寄件者: WARREN WONG <[REDACTED]>
寄件日期: 2026年06月23日星期二 10:22
收件者: Sheren Si Wai LEE/PLAND
主旨: Re: Application No. A/NE-TKL/844
附件: 排水建議書.pdf

Proposed Temporary Warehouse and Open Storage
of Construction Material with Ancillary Facilities for
a Period of 3 Years and Associated Filling of Land at
Lot 207 in D.D. 84, Ta Kwu Ling, N.T.

Drainage Proposal

DRAWING NUMBER
 FIGURE 2

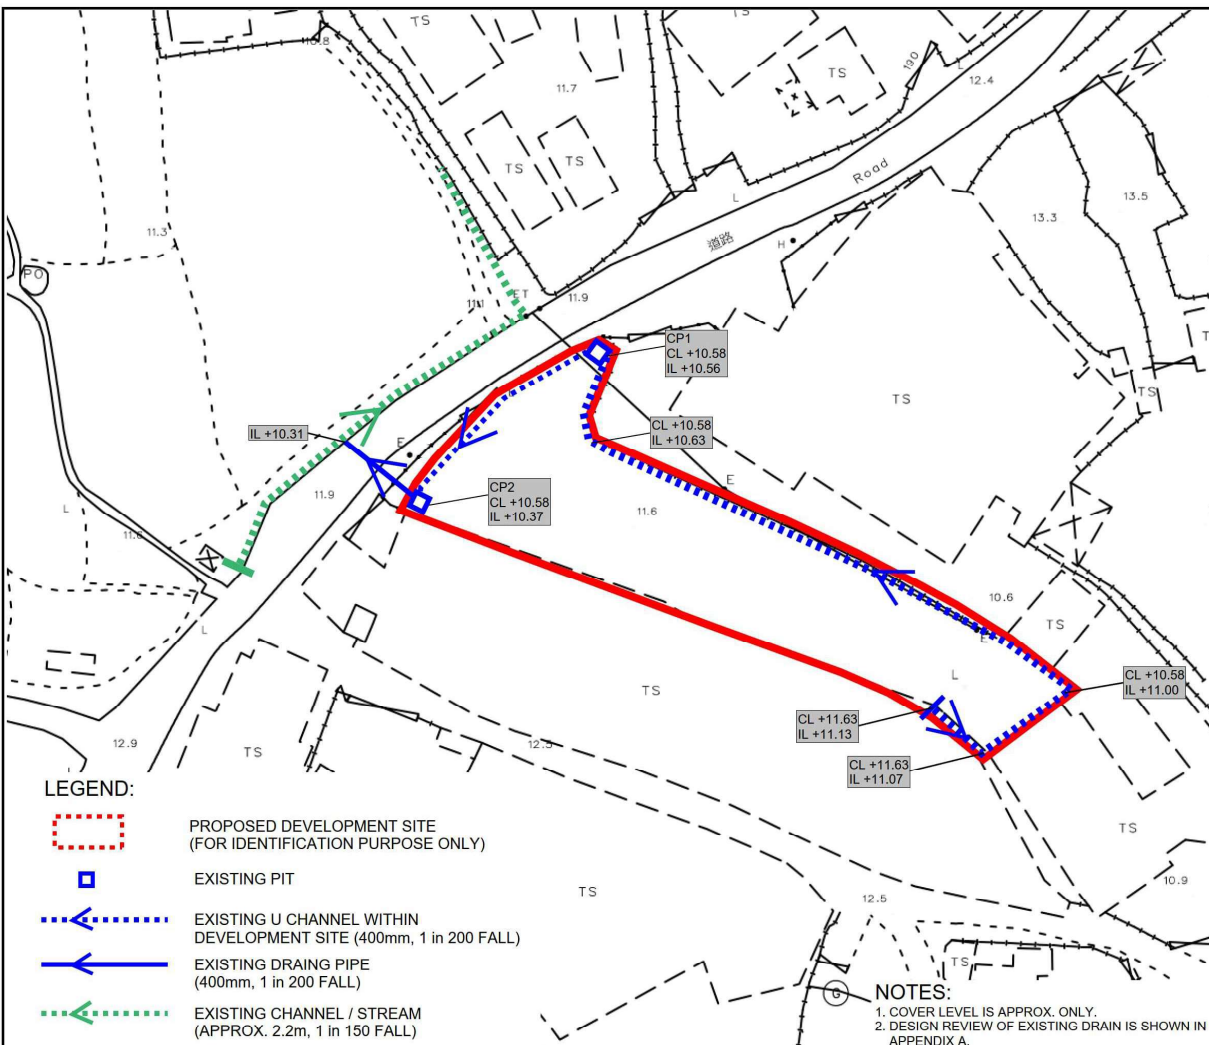
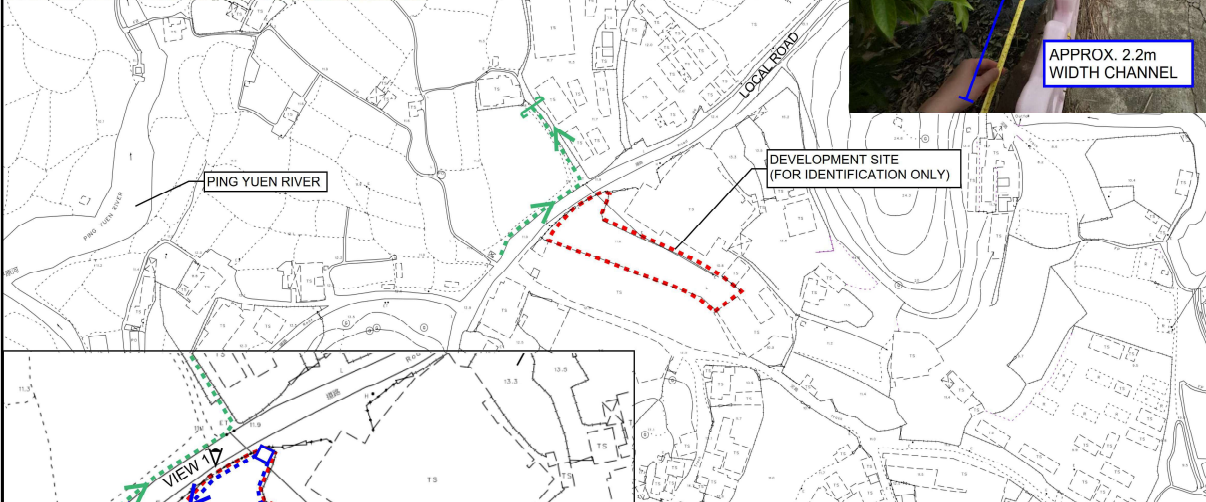
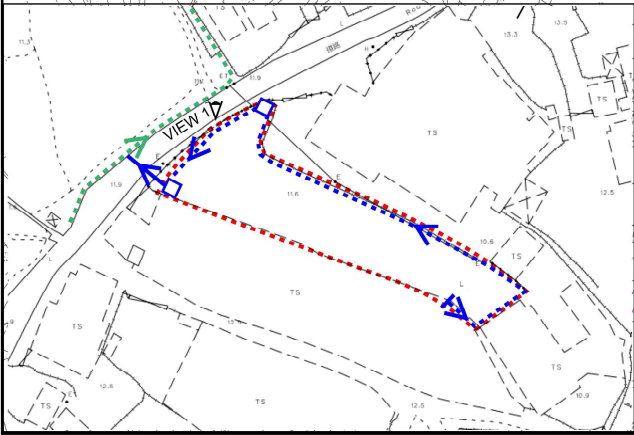
4. Please clarify if the submitted drainage proposal is the same as the one accepted by DSD under the last approved application No. A/NE-TKL/762, and provide the soft copy of the drainage proposal.

今次遞交的排水建議書與上次編號 A/NE-TKL/762 批准了的相同，並沒有更改。請參考附件 "排水建議書.pdf"
